13-23 Gibbons Street, Student Accommodation Modification 4

Internal and external changes
State Significant Development Modification Assessment
(SSD 9194 MOD 4)

December 2021

Figure 3 | Proposed basement plan. Additional laundry facilities are shown in red cloud. (Source: Submitted architectural plans)

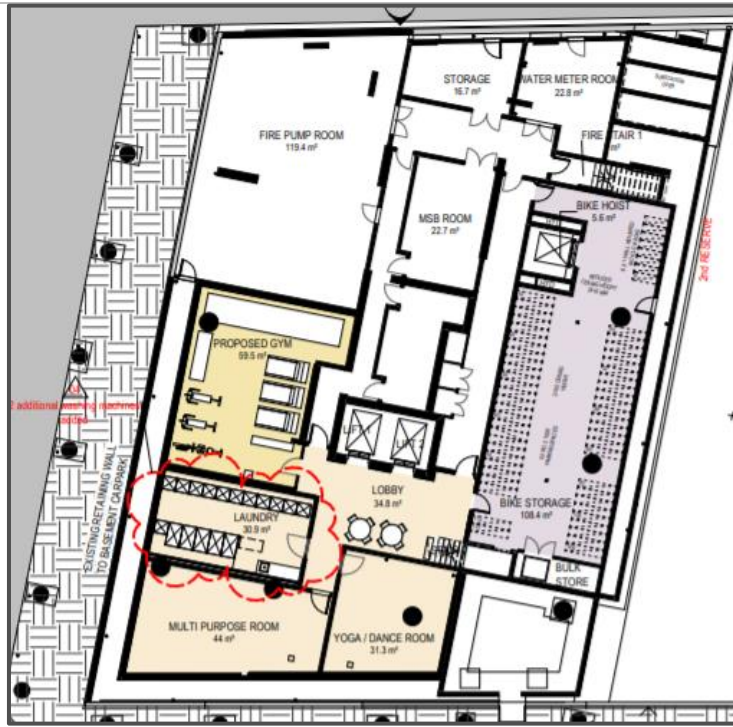
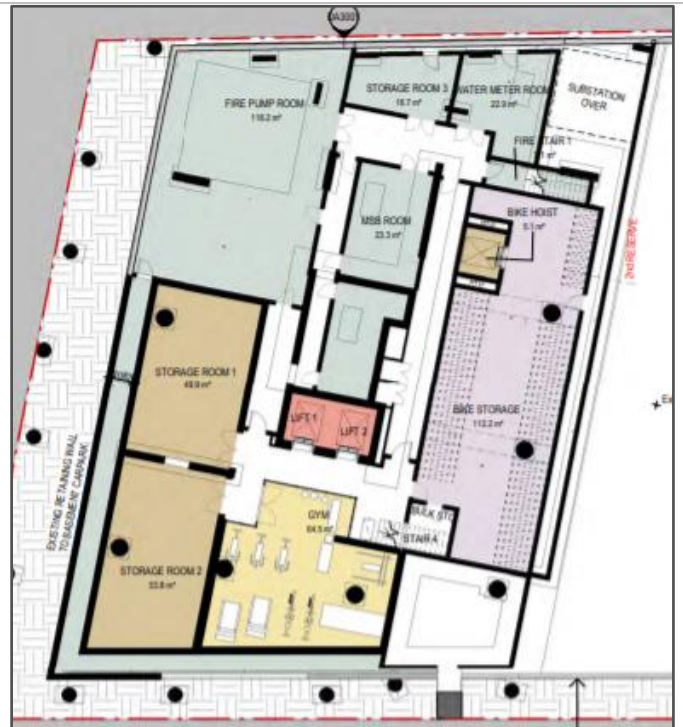
<u>Washing machines</u> • The proposal seeks to increase the number of washing machines on site from 10 to 12. This results in a ratio of 1 machine per 39 residents from 1 machine per 42 residents. • The Applicant states that residents can monitor the availability of washing machines digitally, thereby decreasing waiting times between uses and ensure efficient operation. • The required rate under the SDCP 2012 provides for one washer / dryer per 12 students. • The Department notes the original development (SSD 9194) supported a ratio of 1 washer/dryer per 42 residents and was considered acceptable based on the Applicant's experience with laundry demands from students within previous student accommodation developments. • The Department supports the number of machines increasing which would provide an improved ratio, albeit a minor one.	
Laundry facilities	<u>Dryers</u> • Additional dryers have not been proposed, retaining 10 dryers as approved. This results in a ratio of 1 machine per 47 students. • The approved number of dryers in the original development (SSD 9194) provided 1 machine per 48 students. • The Applicant notes that there is less demand for dryers which are used approximately 25% less often as the washing machines. • The Applicant has stated that during an academic term it is approximated that the needs of the residents can be serviced by 4 daily loads per machine for a total running time of 2 hours. Residents can monitor the availability of the machines digitally (through smart-phone application), reducing the downtime of machines. • The Department considers the variation acceptable as it is a marginal service improvement from the approved number of dryers under SSD 9194 and is therefore supported.

Figure 9 | Section through typical tower room for approved (top) and proposed (below). Sprinklers are circled in red. (Source: Applicant's RRTS).

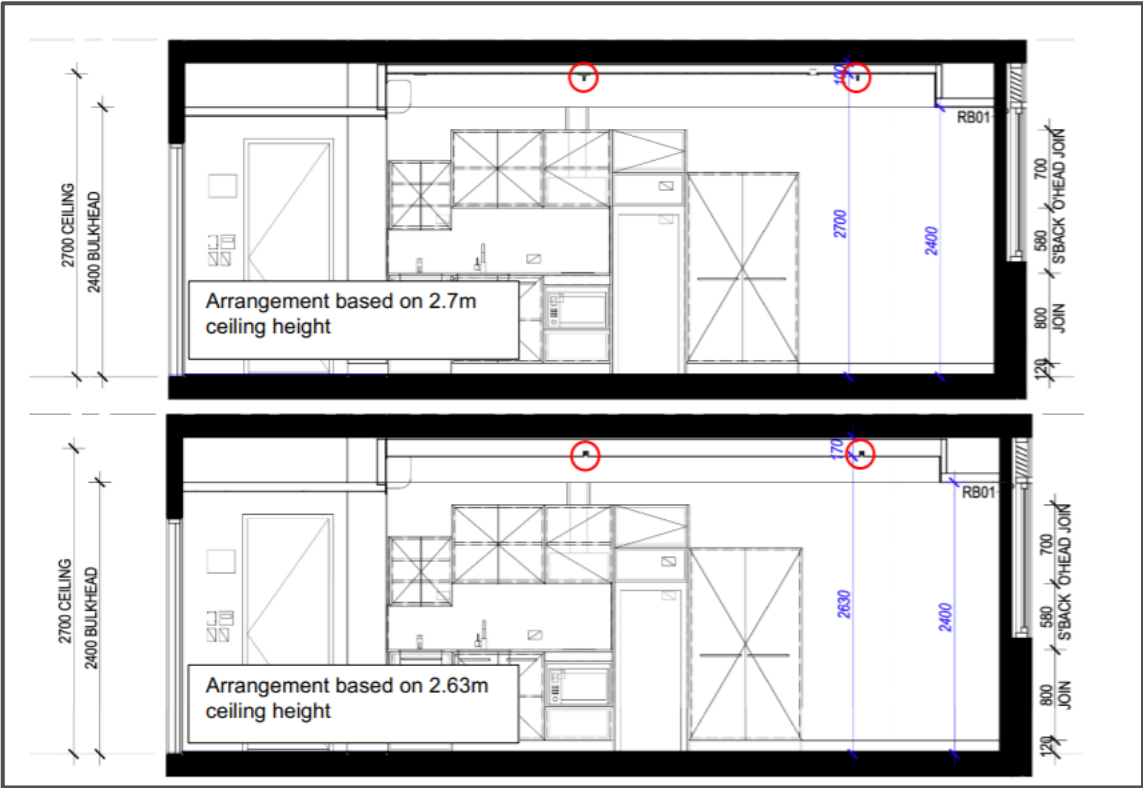
- The proposal seeks to reduce floor to ceiling heights by constructing sprinkler heads flush (or concealed) within the ceilings (**Table 1**).
- For Levels 1-4 this reduced overall ceiling heights from 2.95 m to 2.8 - 2.88 m. For levels 5-18, this reduces overall ceiling heights by 7cm from the original approval.
- There are no proposed changes to the basement ceiling height of 2.85 m.
- The Department considers the proposed change acceptable as the ceiling heights comply with (and exceed) the minimum requirement of 2.4 m under the BCA and concealed sprinklers provide an acceptable amenity outcome by improving safety for residents.

The Department recommends Condition A2 is updated to reflect the revised design drawings.

Figure 10 | South elevation plan (external louvres proposed are shown in red clouds on ground floor). (Source: submitted architectural plans).

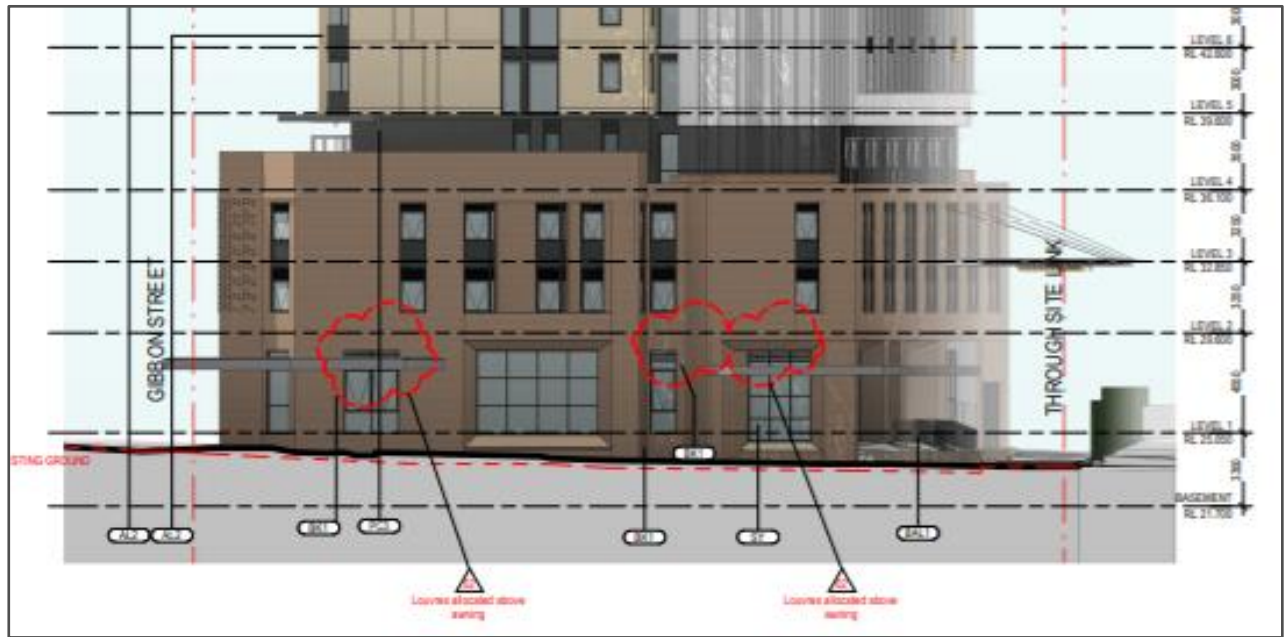
External louvres	• The proposal seeks to include external louvres to the ground level openings on the southern elevation, above the awning level.	The Department recommends Condition A2 is updated to reflect

- The Applicant states that the minor change is to allow for the provision of mechanical ventilation to the new basement common areas and laundry. - The Department considers the proposed louvres acceptable they would provide ventilation to the basement and would be well integrated with the external facade of the building.	the revised design drawings.
Accessibility	- The proposal seeks to convert 6 approved adaptable rooms to 6 twin-share rooms (rooms 2.01, 3.01, 2.14, 3.14, 2.25 & 3.25). - The Applicant Building Code of Australia (BCA) requirements for accessible rooms is based off the number of rooms and not the number of beds, and thus by adding additional beds into existing rooms this does not require any change to the number of accessible rooms. - The Department notes the building has 12 approved accessible rooms (including 6 adaptable rooms). - The Applicant has provided an accessibility statement in support of the proposed modification stating that the conversion of adaptable rooms is acceptable on a needs-only basis as long as a management plan is in place to be able to relocate the original occupants. - The Applicant subsequently provided further information which stated that the modification would still maintain 6 accessible and 6 adaptable rooms despite the conversion of 6 adaptable rooms to twin share. - The Department considers the proposed changes acceptable, subject to the recommended conditions, including that 6 accessible and 6 adaptable rooms are provided.	The Department recommends Conditions B45A and Condition E39 be included to ensure that the proposal provides a minimum 6 accessible and 6 adaptable sole occupancy units prior to the issue of Construction Certificate and Occupation Certificate, respectively. Condition E5 to be updated to reflect these access changes to the Operational Plan of Management.
